MEMORANDUM

FROM: GRAEF
Craig Huebner, AICP, Village Planner

DATE: December 1, 2020

SUBJECT: Review of the following:

Figure 3: Staff-recommended Kiddle Lane redesign concept

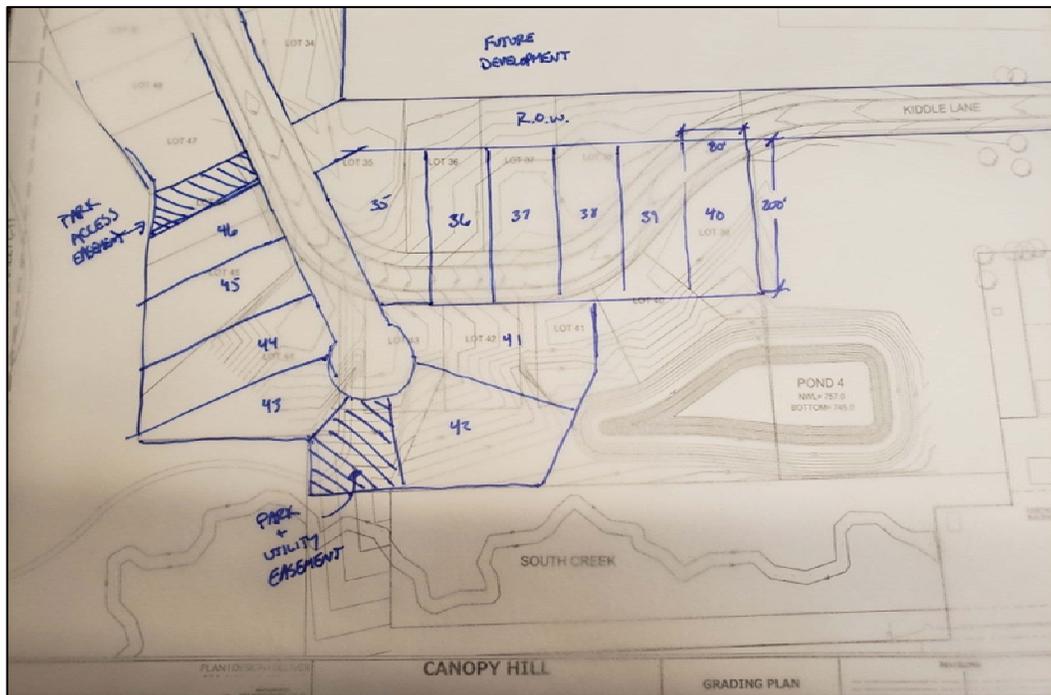
- (5) 58th Road intersection with Highway 45: Remove slip lane configuration (unless TIA report mandates this configuration);
- (6) Resolve the existing “Wisconsin Telephone Company Easement” development impact at lots 1-2, 17, 96-103. The easement location appears to cut lots in half;
- (7) Ensure Pond 4 is appropriately sized to accommodate future senior living development at Lot 4 of proposed CSM and is located entirely within Outlot 2;
- (8) Revise design layout of Kiddle Lane and surrounding lots 35-46 according to Village staff recommendations (see Figure 3 below);
- (9) Submission of TIA with review and approval by WisDOT and Village Engineer.

Redesign Concept achieves the following Village staff desires: (1) Provides a much clearer access and frontage to the adjacent parcel to the north; (2) Simplifies street and lot layout while maintaining the same amount of lots; and (3) Adds park access at the terminus of Kiddle Lane (a bit more intuitive as to where one of the park access points would be).

- (6) Revise design layout of Kiddle Lane and surrounding lots 35-46 according to Village staff recommendations;
 - (7) Submission of TIA with review and approval by WisDOT and Village Engineer;

Figure 5: Staff-recommended Condo Plat Redesign Concept

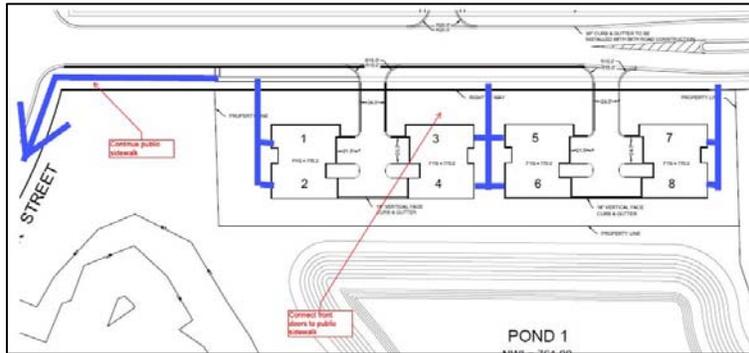
- (3) Explore revision to site design. Figure 5 below shows a shift in placement of a few of the townhomes to create more organized open spaces and groupings of buildings;

- (4) Adjust groupings of buildings in the northern portion of the site and eliminate each sidewalk between each building (doesn't seem likely that a resident would use this path nor would it be intuitive for a guest to walk through to the front door instead of being invited through the garage). Instead, make the new space between groupings of buildings a more formal open/landscaped space with parking that includes a sidewalk to the front doors. This would be better understood for guests to park and enter via the front door of townhomes (see Figure 5);

- (5) Landscape Plan: Create more formal park - like spaces that have a stronger landscape composition and form that is recognizable as a place within the townhome development area. Proposed open space design (as submitted) is just what's left over with no design hierarchy (see Figure 5).

- (3) Provide a revised site design according to staff comments in Section VI of this memo;
 - (4) Landscape Plan: Create more formal park - like spaces that have a stronger landscape composition and form that is recognizable as a place within the townhome development area;

Figure 6: Proposed Zoning Exhibit (submitted by Applicant with Planner comments in red)

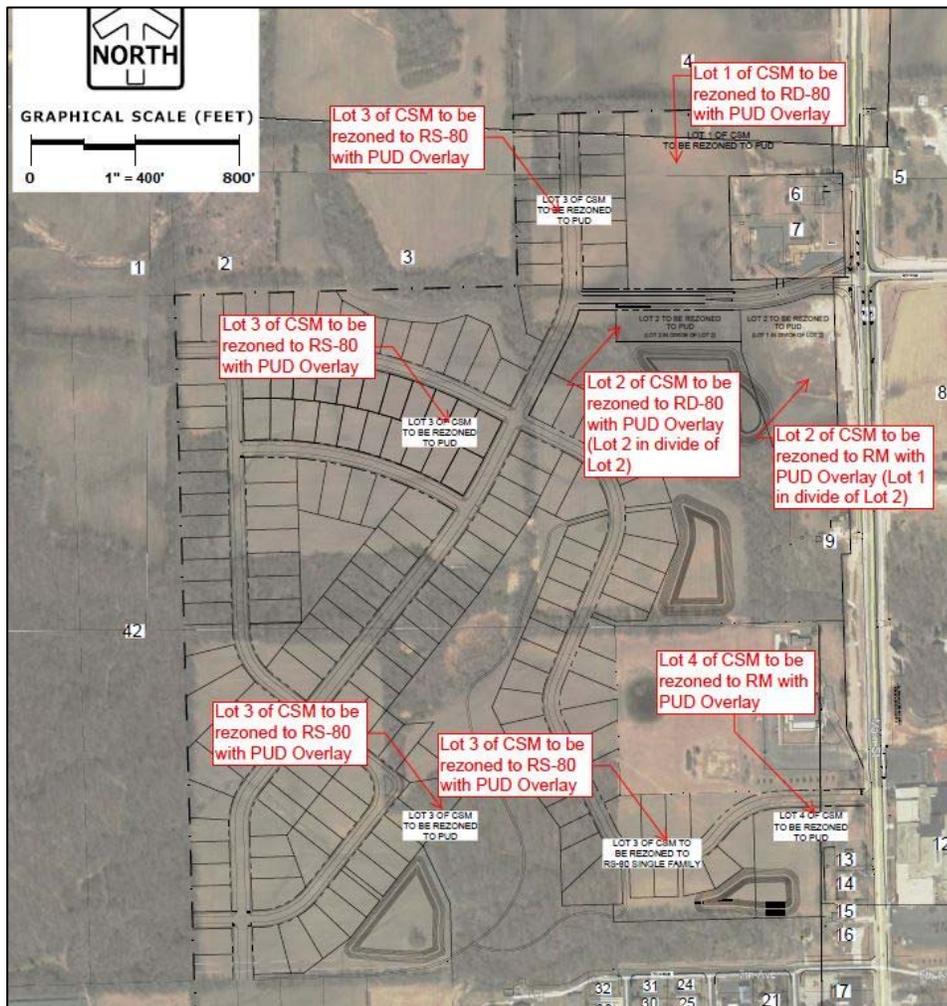
Figure 6 shows the rezoning exhibit submitted by the Applicant with comments in red that were provided by GRAEF and are part of the conditional approval for the base rezoning agenda item:

- (1) Submit a revised rezoning exhibit to accurately label proposed zoning.

- a. The request of Newport Group, LTD (Owner) and Bear Development, LLC (Applicant) for a Zoning Amendment from RS-90 with PUD Overlay District to RS-80, RD-80, and RM for the address NWQ Hwy 45 & 58th Road, Union Grove, WI (Subject Property), subject to the following conditions:
 - (1) Submission of a revised rezoning exhibit to accurately label proposed zoning;
 - (2) Village approval of CSM and Final Plat for the Subject Property; and
 - (3) The Applicant shall address any other issues which are raised by any approving or objecting authority, which the Village Plan Commission and/or Village Board deem necessary for the Applicant to address in the application materials, and which have been made, or may be made, by the Village Administrator, Village Attorney, Fire Chief, Village Engineer, and Village Planner.

Figure 8: Woodland Exhibit (submitted by Applicant)

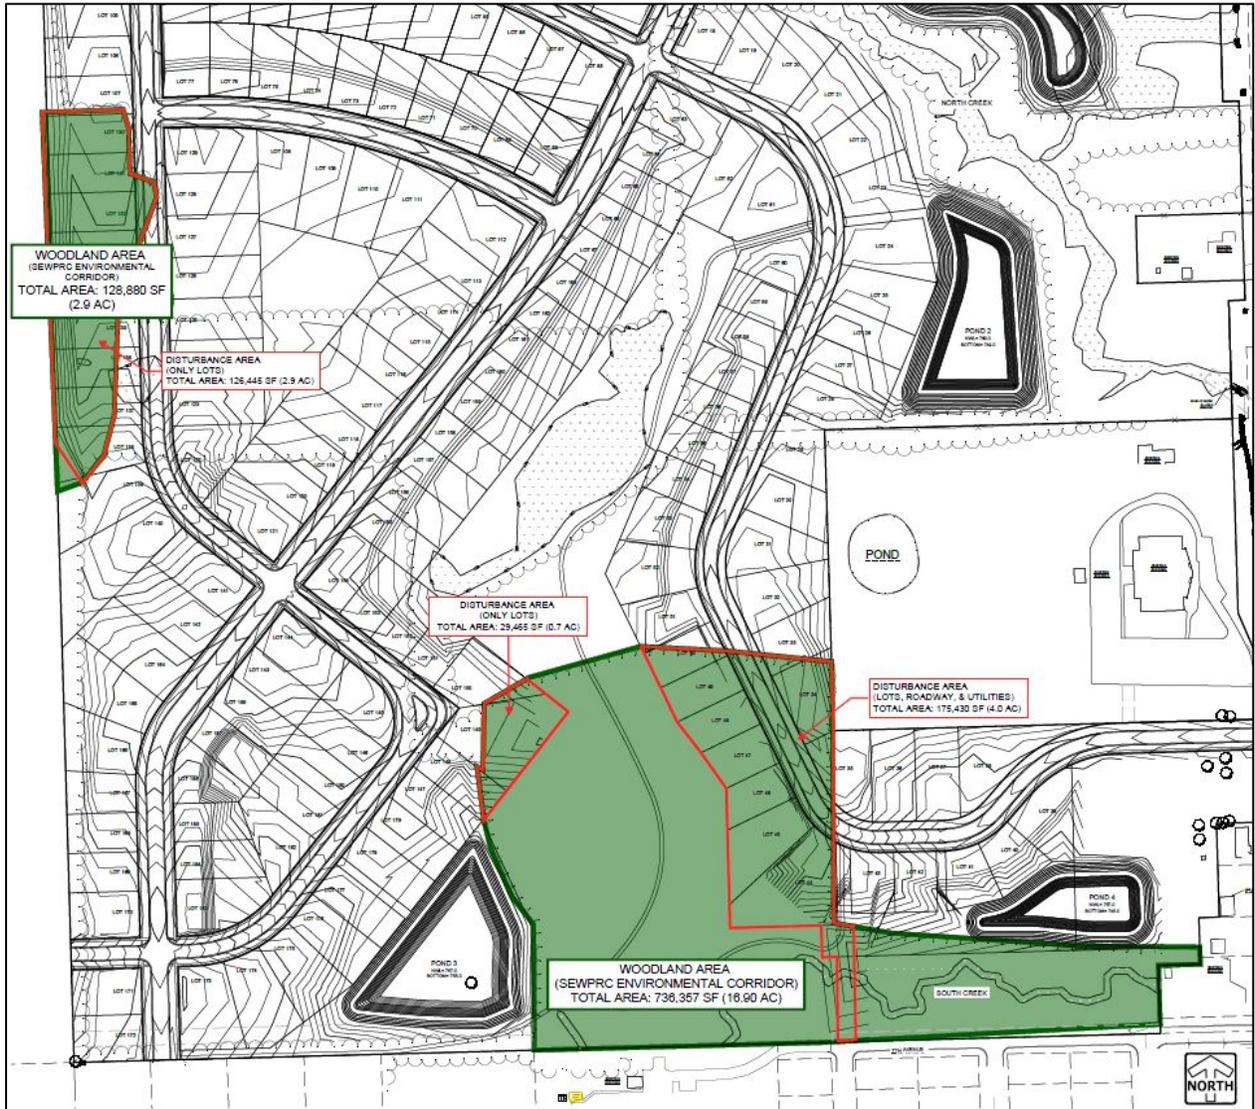
- (1) The site contains a large percentage of natural features. Two areas are identified by Southeastern Wisconsin Regional Planning Commission (SEWRPC) as environmental areas that warrant possible conservation tactics. The areas include a "Secondary Environmental Corridor" and an "Isolated Natural Resource Area". Both areas include mature woodlands. The Village Planner requested the Applicant to provide the below exhibit and quantify three things: (1) Total area of SEWRPC Environmental Areas, (2) Total area proposed to be disturbed; and (3) Total area proposed to remain.

- (2) Woodland area summary table (provided in "2020-11-18 CANOPY HILL WOODLAND EXHIBIT.pdf"):
 - i. TOTAL AREA OF WOODLANDS WITHIN SEWRPC ENVIRONMENTAL CORRIDORS: 865,237 SF (19.8 AC)

- ii. TOTAL AREA TO BE DISTURBED: 331,340 SF (7.6 AC) (38.4%)
 - iii. TOTAL AREA TO REMAIN: 533,897 SF (12.20 AC)(61.6%)
- (3) The Plan Commission shall review and decide if the proposed disturbance is appropriate for the development.

Figure 11: Staff-required addition of sidewalks to multifamily site design

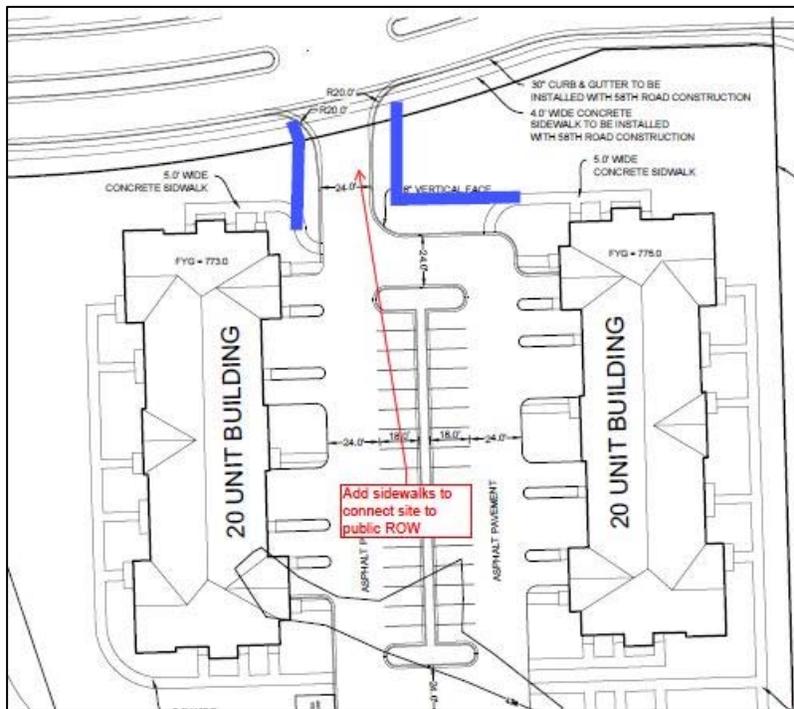
- (1) Applicant shall revise site design to include sidewalk connection from multi-family structures to 58th Road public sidewalks.

- a. The request of Newport Group, LTD (Owner) and Bear Development, LLC (Applicant) for a Site Plan Review for multifamily development on proposed Lot 1 of the CSM Redivide, subject to the following conditions:
 - (1) Applicant shall revise site design to include sidewalk connection from multi-family structures to 58th Road public sidewalks;
 - (2) Village approval of a Zoning Amendment, PUD Zoning Overlay, and CSM for the Subject Property;
 - (3) Village approval of a Developer's Agreement; and
 - (4) The Applicant shall address any other issues which are raised by any approving or objecting authority, which the Village Plan Commission and/or Village Board deem necessary for the Applicant to address in the application materials, and which have been made, or may be made, by the Village Administrator, Village Attorney, Fire Chief, Village Engineer, and Village Planner.
